**ZONING AMENDMENT &
PLANNED UNIT DEVELOPMENT
STAFF REPORT**

NAME Stratford LLC

LOCATION North side of Grelot Road, 160'+ West of Chimney Top Drive West

CONTEMPLATED USE Planned Unit Development Approval to allow two buildings on a single building site and Rezoning from R-1, Single-Family Residential, to B-1, Buffer Business, to allow a two-building office complex.
It should be noted, however, that any use permitted in the proposed district would be allowed at this location if the zoning is changed. Furthermore, the Planning Commission may consider zoning classifications other than that sought by the applicant for this property.

SITE PLAN

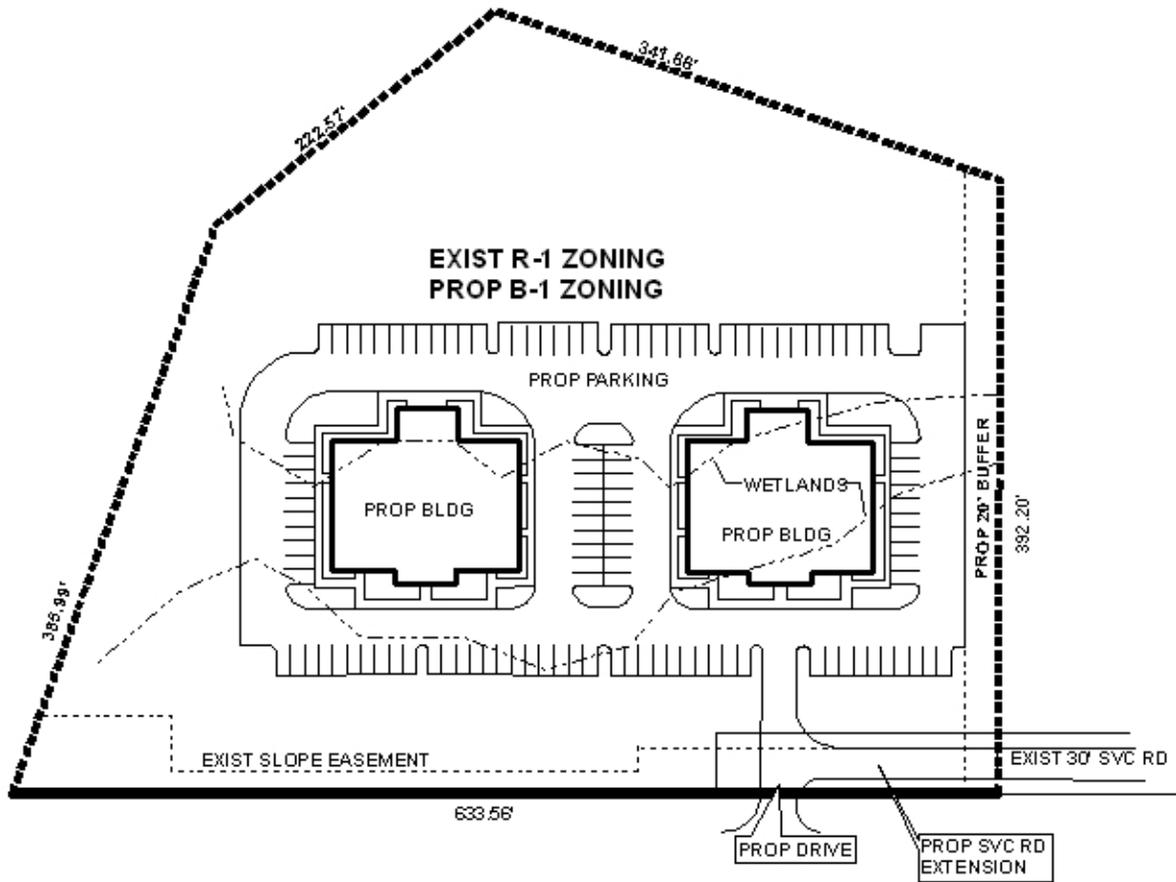
The Zoning and PUD site plans provided for the current application depicts two one-story 11,080 square foot office buildings and 120 parking spaces. The site plan also depicts the extension of the existing service road East of the site onto the property, and one curb-cut onto Grelot Road. It appears that the proposed service road would be private, however it is not clear if this is the case.

Regarding the PUD site plan, the parking requirements in the Zoning Ordinance state that each 11,080 square foot office building would require 37 parking spaces, for a total of 74 spaces. The site plan states that 111 spaces are “required.” The site will exceed the minimum number of parking spaces.

The site plan also shows that the two proposed buildings and parking area will be situated on the wetlands that exist on the site, as well as the primary natural drainage, which goes from the East side of the site to the West side of the site, draining into a branch of Milkhouse Creek. It appears that the development could be redesigned to reduce the impact to the existing wetlands and natural drainage system.

There is no indication on the site plan as to the proposed location of any dumpster or other waste storage facility. If the applicant utilizes a dumpster, the location of the storage area for the dumpster must be indicated on the site plan, and the location and required screening must comply Section 64-4.D.9. of the Zoning Ordinance, as well as with all other applicable regulations.

There is no indication of storm water detention facilities on the site plan, but such facilities will likely be required. The site plan should depict the general location of these facilities.

The site plan does not depict the 30-foot minimum building setback line from Grelot Road, as depicted on the approved preliminary plat. The site plan does depict, however, a 20-foot wide undisturbed natural buffer along the East side of the site, to protect the existing single-family residences to the East.

Regarding the proposed extension of the service road from the East onto the site, it will facilitate the access for the site, but it may increase the traffic volume for the access from the service road to Grelot Road where the service road intersects with Grelot and Chimney Top Drive West (where there is also a break in the median of Grelot Road). The access onto Grelot Road at Chimney Top Drive West is across the street from the entry/exit of an existing apartment development, thus there appears to be a high probability of traffic conflicts at this location. Also, a determination should be made as to whether the “service road” extension will be public or private. If public, the right-of-way should be dedicated to the City of Mobile.

A sidewalk along Grelot Road will be required as part of the development, if approved. The site plan should be revised to show the sidewalk.

The site will have adequate area to meet the minimum requirements for landscape area, as required by the Zoning Ordinance. The site plan does not, however, show specific compliance with the tree requirements of the Ordinance.

- 1) based upon the denied Zoning application; and
- 2) the site plan does not appear to take into account the natural features of the site.
